## Executive Director's Recommendation

**PROJECT****Irrigation, Drainage, Water Collection, and  
Re-landscaping of the Mall – Phases II and  
III**

*The National Mall  
Washington, DC*

*Preliminary and final approval of  
site development plans*

Figure 7: Diagram of event intensity along the Mall

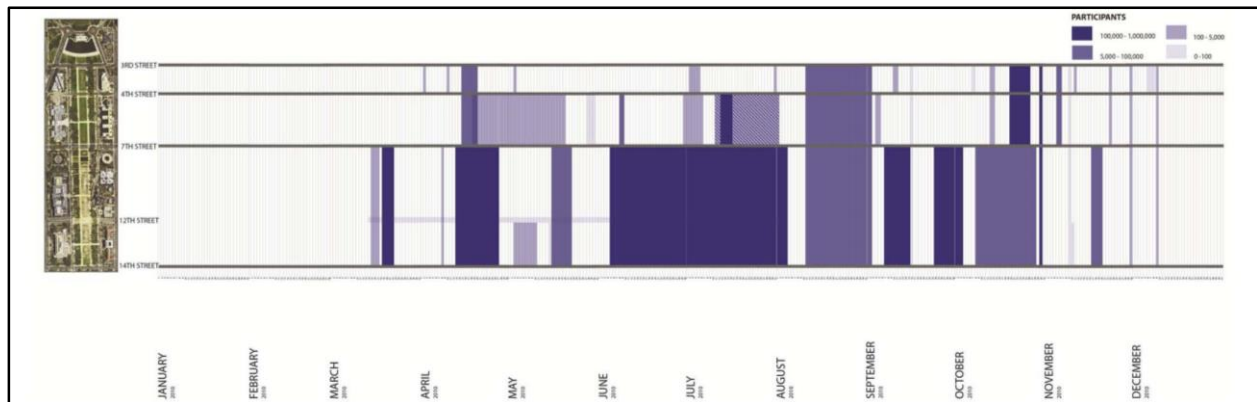
In determining how and where to widen the walkways on the Mall, NPS analyzed the requirements of typical events held on the Mall every year. This analysis confirmed that the existing configuration of the walkways between 7th and 14th Streets could not meet the needs of these events without strategically widening them. The highest intensity of use was during the summer months and also the lawn panels between 7<sup>th</sup> and 14<sup>th</sup> Streets held the largest events with the most participants. If the walkways were not widened, there would be a need to place tents and equipment on the lawn panels. The analysis indicated that structures placed on the lawn would cause the death of the turf in 9 days. The results of the analysis indicated that placing tents and structures on non-turf areas was a sustainable practice that would protect the turf.

Based on the size and number of the most common tents and structures used during events, NPS devised a design that would allow for the largest tents to be accommodated in specific locations along the walkways. For example, a large tent of 60 or 80 feet will be accommodated along the 9th or 12th Street corridors where the walkway will be widened to 105 feet. With a 80 foot tent in place, both of these walkways will also accommodate a 15 foot wide pedestrian walk and emergency access route. Approximately 10 feet will be needed for tent/stage support space along the walkway. Along 10<sup>th</sup> and 13<sup>th</sup> Street where the walkways will be widened to 60 feet, a 35 foot tent will be accommodated with the same 15 foot wide pedestrian walk and 10 feet for tent/stage support space. The east-west walkways will remain at 40 feet and will accommodate smaller tents up to 15 feet in size, a 15 foot pedestrian/emergency access way, and a 10 foot wide area for existing site furnishings.

Figure 8: Sections indicating possible tent layout on walkways

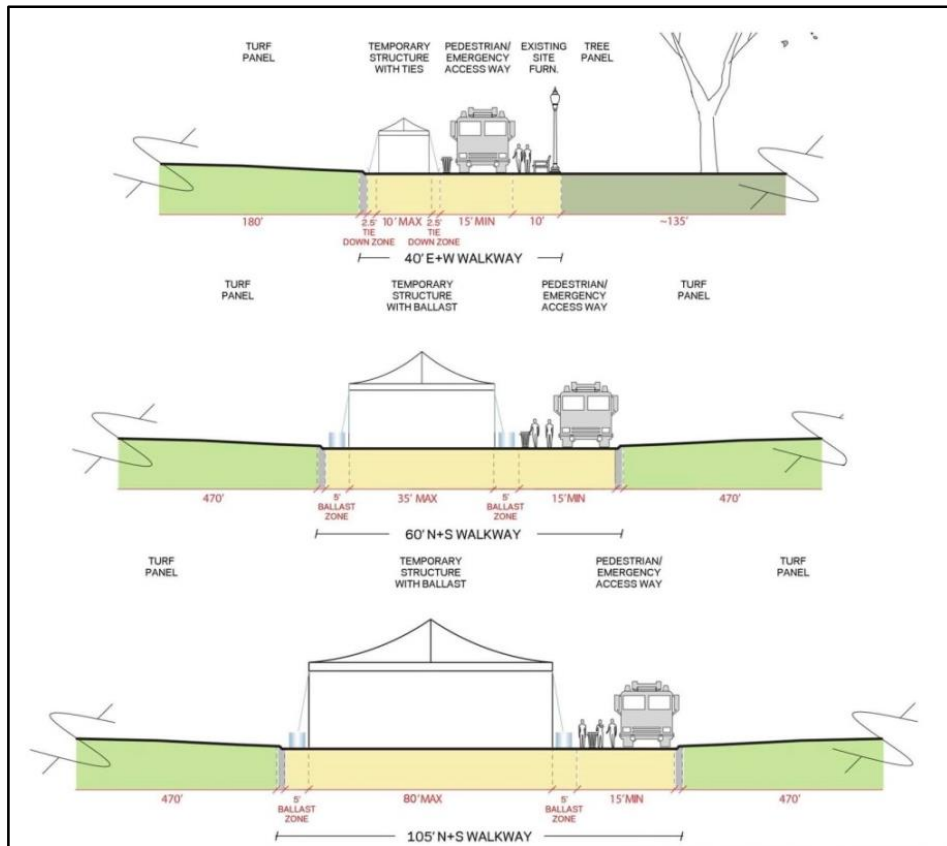
Based on the information provided by NPS regarding the intensity of events held on the Mall, in order to protect the lawn panels and turf, widening the walkways in strategic locations is key to preserving and rehabilitating the historic landscape. In addition, by minimizing the width of the non-turf areas to 105 feet in only 2 locations – along 9<sup>th</sup> and 12<sup>th</sup> Street, the continuous greensward and views across the Mall between the U.S. Capitol and Washington Monument will be maintained. Therefore, because the overall character of the continuous greensward or tapis vert of the Mall will be maintained, staff recommends the Commission approve the preliminary and final site development plans for the reconstruction of the center lawn panels.
